BRF-034-7(154)--38-90

BEAR CREEK AND CPKC RR 4.2 MI W OF CO RD H35

PRELIMINARY PLANS

D2 Questions for District 5 – with Responses in GREEN Text

BRG TSL Longitudinal Section Along CL Approach Roadway

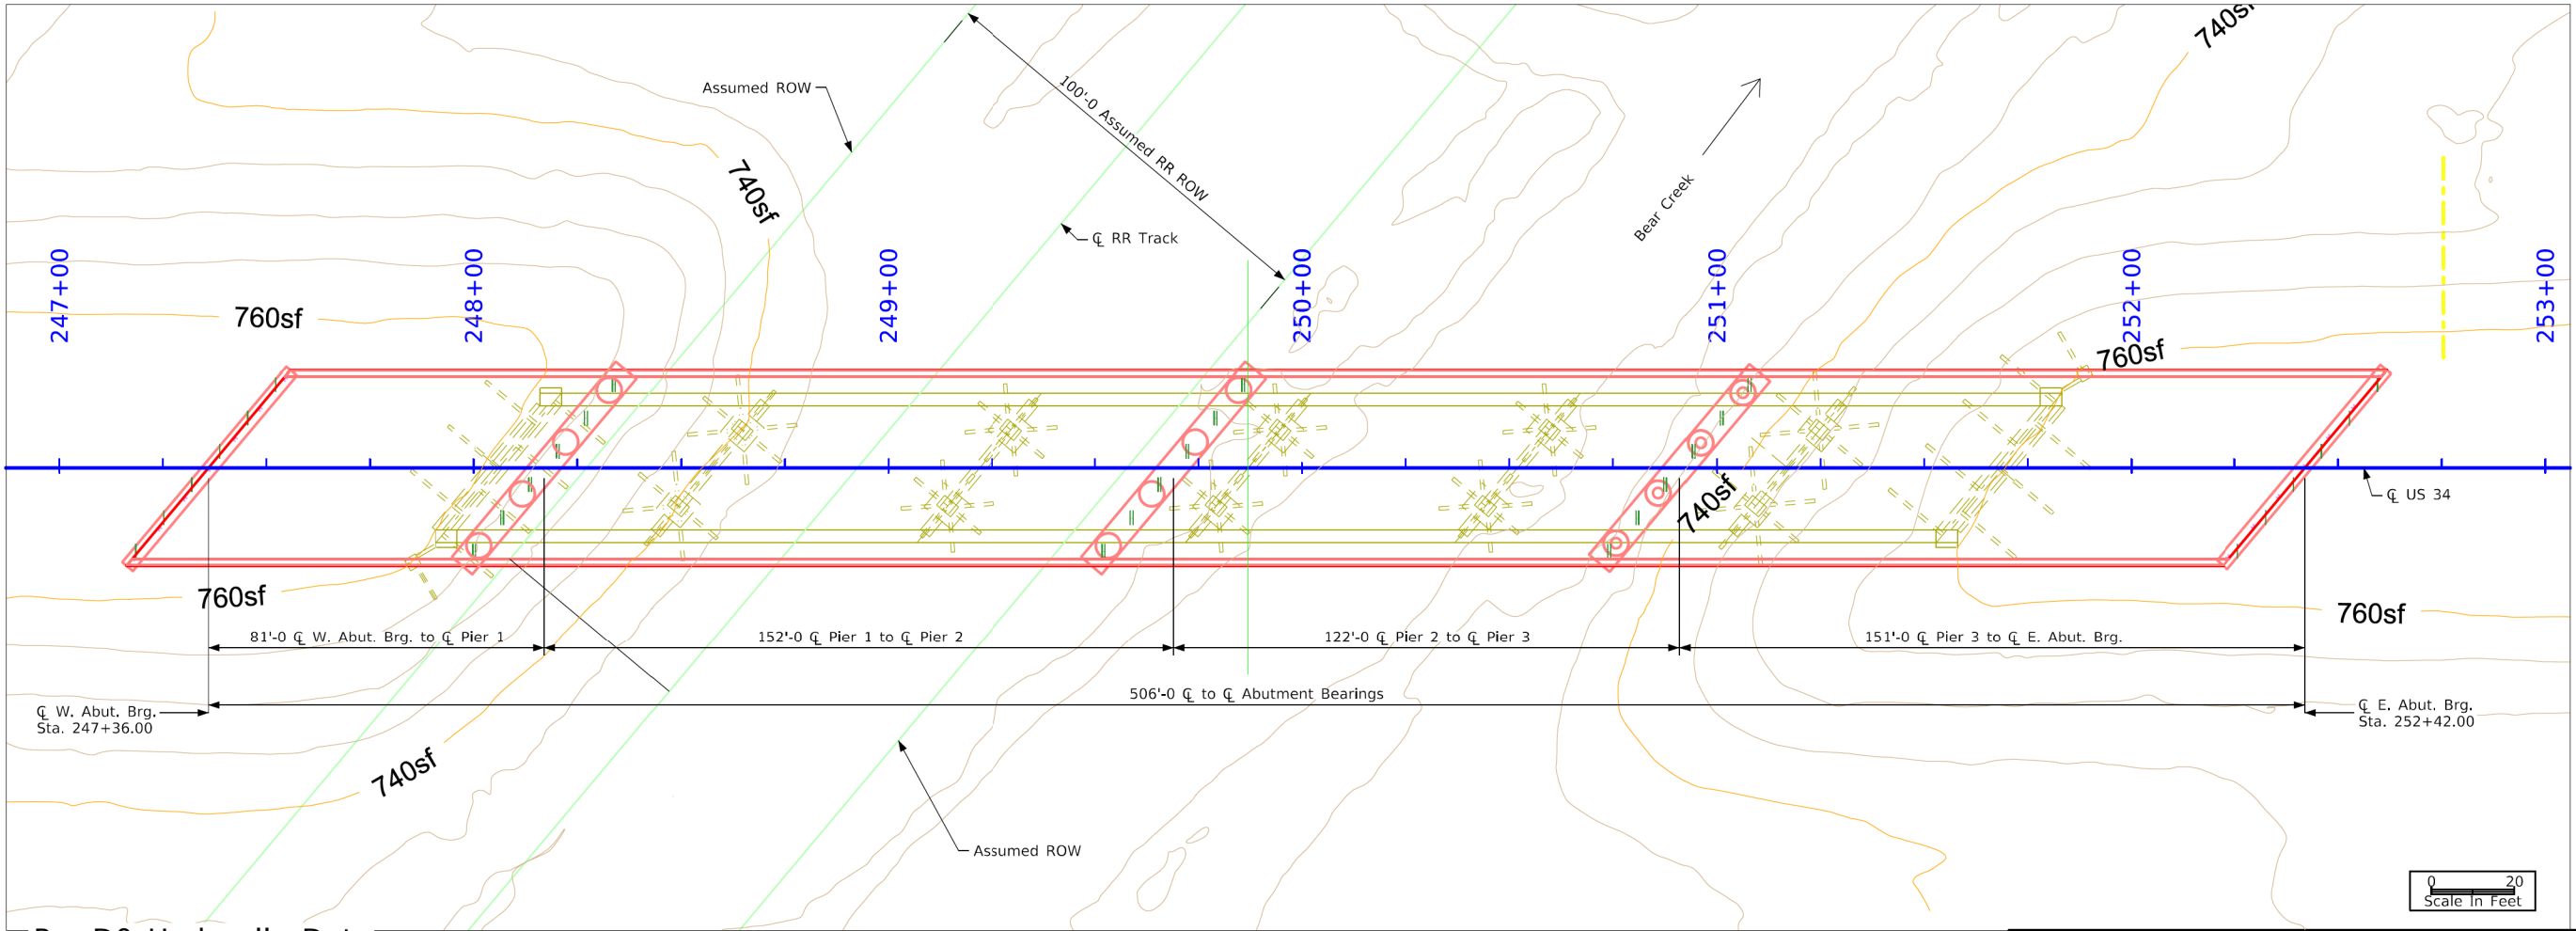
c. The proposed 40-degree skew for a PPCB bridge being greater than 30 degrees was discussed and approved by the BSB. The rationale is to match the existing foundation skew and to provide a better fit to the RR and channel skew than a 30-degree skew bridge would provide.

d. Due to the high fills anticipated to exceed 30 feet, 3:1 berms are shown at the concept stage. Actual fill heights and TSL preliminary berm design slopes shall be verified during the preliminary B1

- development. Potentially, Soils Design may need to be contacted for an initial berm estimate, if proposed fills exceed 40 feet [BDM 3.7.3].
- e. A bench at approximately elevation 725 was considered during the concept hydraulic analysis in order to provide desirable average bridge velocity. Such a bench was considered for placement on the east side of the channel to avoid any potential impact to the RR ROW.

- b. Drilled shaft pier foundations shall be considered to reduce potential conflicts between proposed foundations and existing bridge steel piling. The soil profile on the existing bridge plans appears to be acceptable for a drilled shaft design. The pier foundation type determination shall be made during final bridge design. A designer note identifying this effort on the TSL is recommended.

US 34
Bridge Approach Pavement

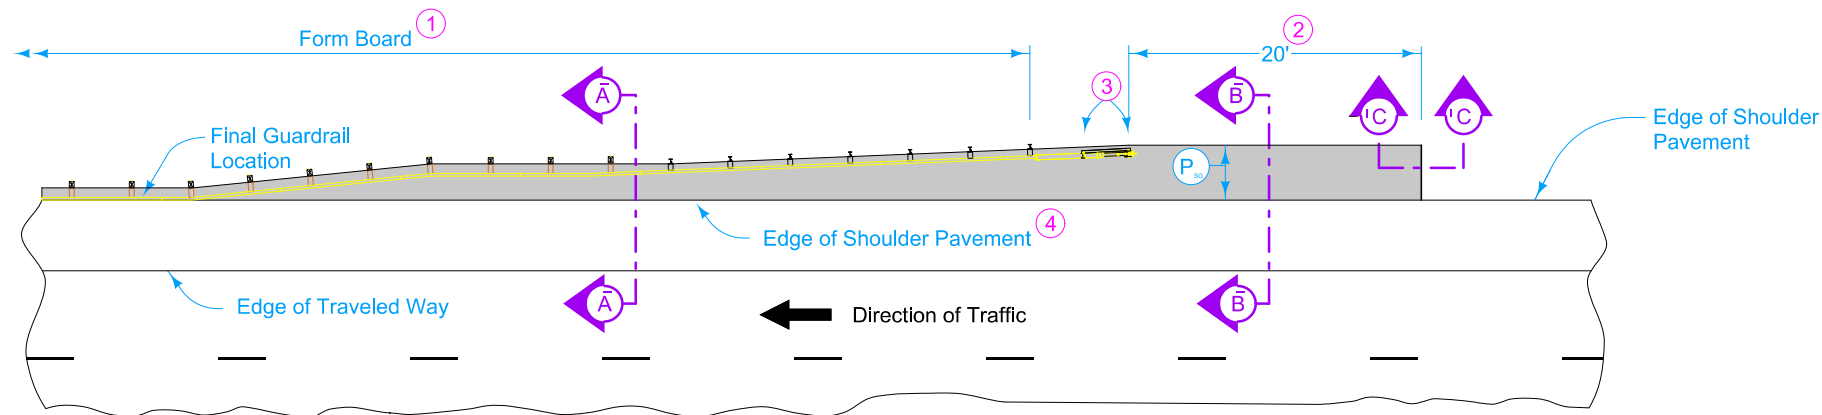
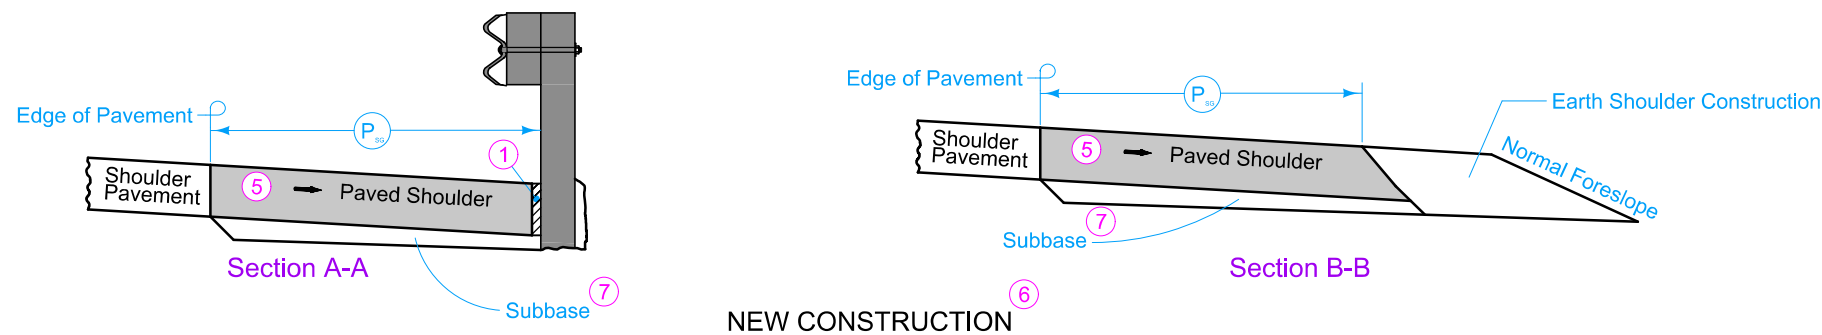
- a. It has not yet been determined whether the abutment is a ‘movable’ abutment or a ‘fixed’ abutment. Please verify the abutment type so that the appropriate Bridge Approach Pavement Standard Road Plan is selected. The Note on the Bridge Approach Typical Section on the B Sheets will be updated as needed.

- b. It appears as though the double reinforced section will be longer than 20’ (as measured along the centerline of the road) because of the skew of the Bridge. The Designer Information for Bridge Approach Pavement section of the Standard Road Plans say “If the need arises for the double reinforced section to be longer than the 20 foot minimum shown on BR-201, BR-202, BR-203, and BR-204, contact the Bridges and Structures Bureau to verify location of the lug for movable abutments.”

- i. 2025-06-10 Field Exam Response: Patricia Schwarz (Bridge Bureau) confirmed that the Bridge Abutment will be a Fixed Abutment. Patricia added that if the Concept or Bridge Documents mention that the Bridge will have a ‘Stub Abutment’ then that means that the Abutment is Fixed. Patricia added that ‘Integral Abutments’ are ‘Movable Abutments’. Patricia added that the ‘Stub Abutment’ was mentioned in the ‘Bridge Cost Analysis and Concept Statement’ and the Statement wasn’t published as part of the Concept Document. Another way to tell if the Abutment is ‘Stubbed’ is if the Bridge Drawings show an abutment with a battered piling.

- i. 2025-06-10 Field Exam Response: Location of the lug for Movable Abutments is not applicable because the Abutment for this Bridge will be Fixed (not Movable).
